From: [Ashley Haigh](#)
To: [Sagan, Barsha](#)
Cc: [Victor Kleinsasser](#); [Daniel Burns](#); [Kyla Dietrich](#)
Subject: RE: Please provide TAC comment response for the File 6193.00 – Crystal Spring Colony Wastewater Treatment Lagoon
Date: October 22, 2024 10:50:17 AM
Attachments: [image001.png](#)
[RPT 2024-07-25 Crystal Springs 200YR FPL 0 Final NW 0105-068-00.pdf](#)

Crystal Springs Colony - New Colony Development 200-Year Flood Level Assessment

**RE: Crystal Springs Colony - New Colony Development
200-year Flood Level Assessment**

Figure 02

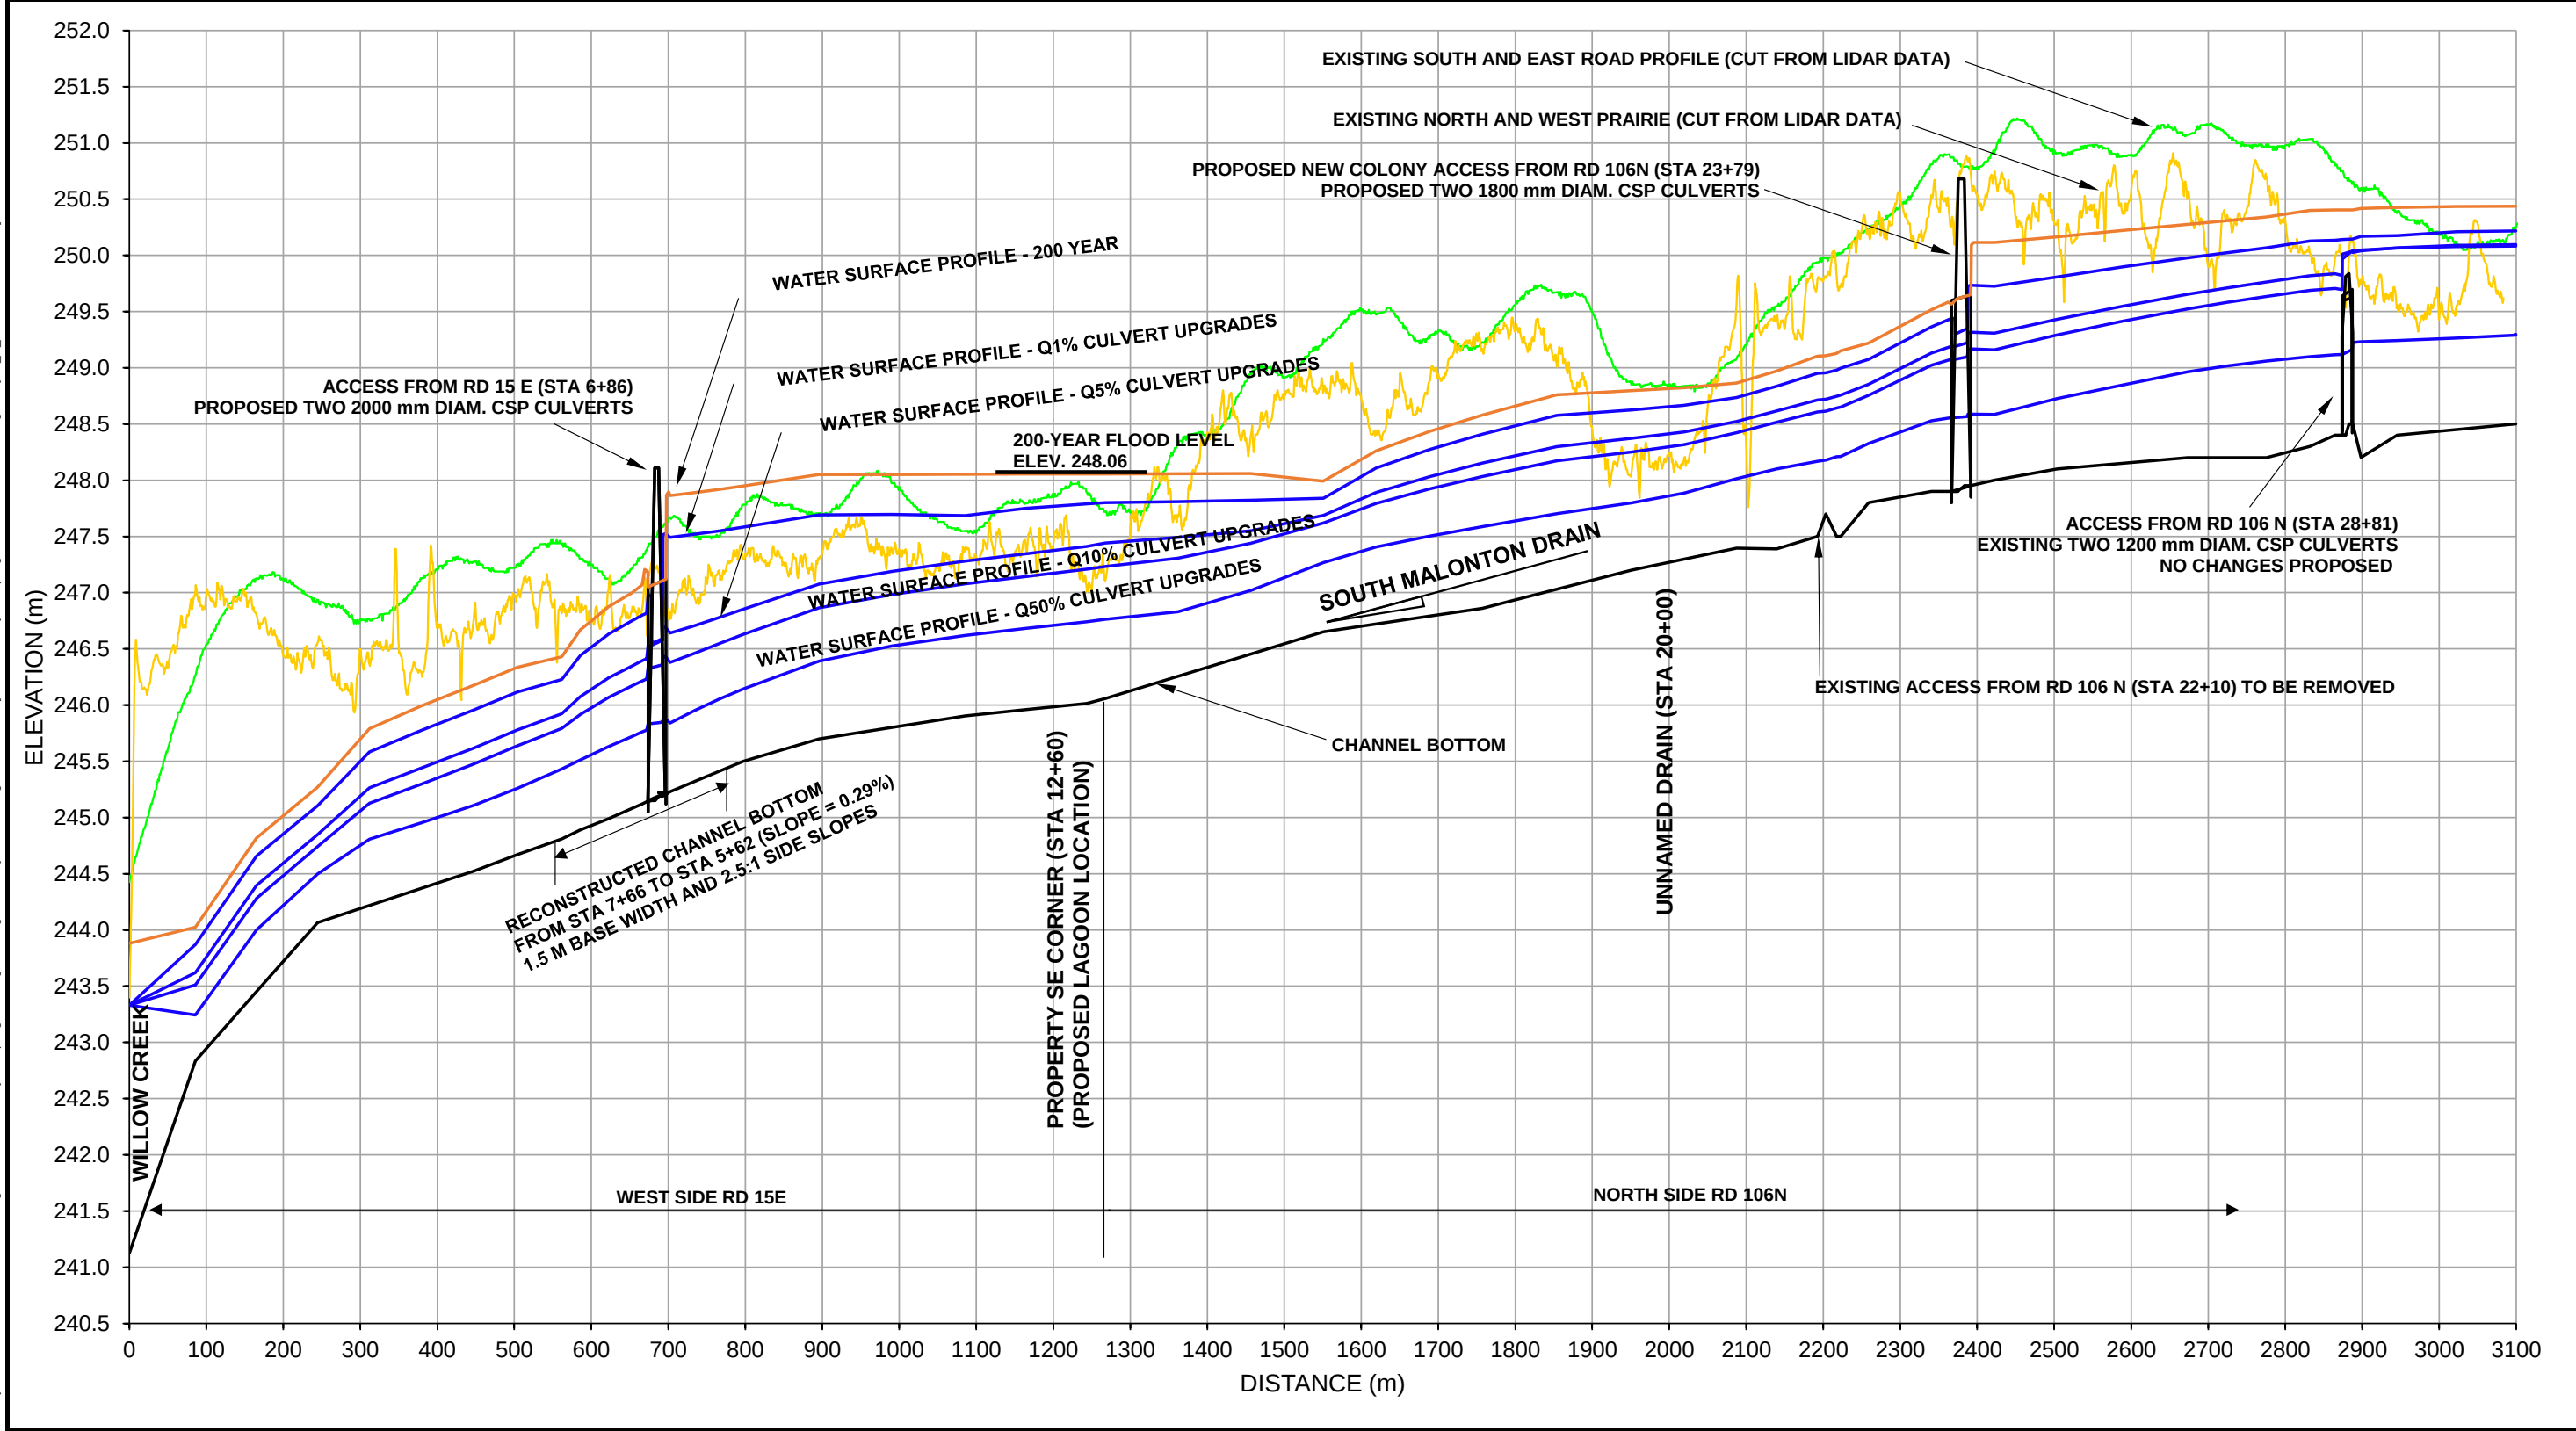
- **Increase the standard for the Flood Protection Level to one based on a 1-in-200 year flood event.**

*The information in the report quotes the 100-year flood protection level, however, the province has been using the 200-year flood protection level as the standard since 2013. We would recommend that this be increased to a **200-year level** to comply with provincial standards.*

Based on this request, additional analyses were commissioned to provide the 200-year flood level. As demonstrated in the attached report from Trek Geotechnical (dated July 25, 2024), the results of the 200-year hydraulic analysis yield a 200-year water level at the proposed lagoon site of 248.06m. Per the submitted design, the proposed lagoon berms are set at an elevation of 248.50m, which exceeds the stipulated 200-year flood level. At this elevation, 0.7m of freeboard is provided above the 100-year flood level, and 0.44m of freeboard is provided above the 200-year level.

The results of the 200-year hydraulic analysis yield a 200-year water level at the proposed lagoon site of **248.06 m**. The proposed lagoon berms designed by others are set at an elevation of 248.5 m which is higher than the 200-year flood level as stipulated by the Province of Manitoba. It is typically prudent to provide 2 feet (0.61 m) of freeboard above the estimated flood level. The designed top of berm provides 0.7 m of freeboard above the 100-year flood level specified in the Gimli Zoning By-Law and 0.44 m of freeboard above the 200-year level.
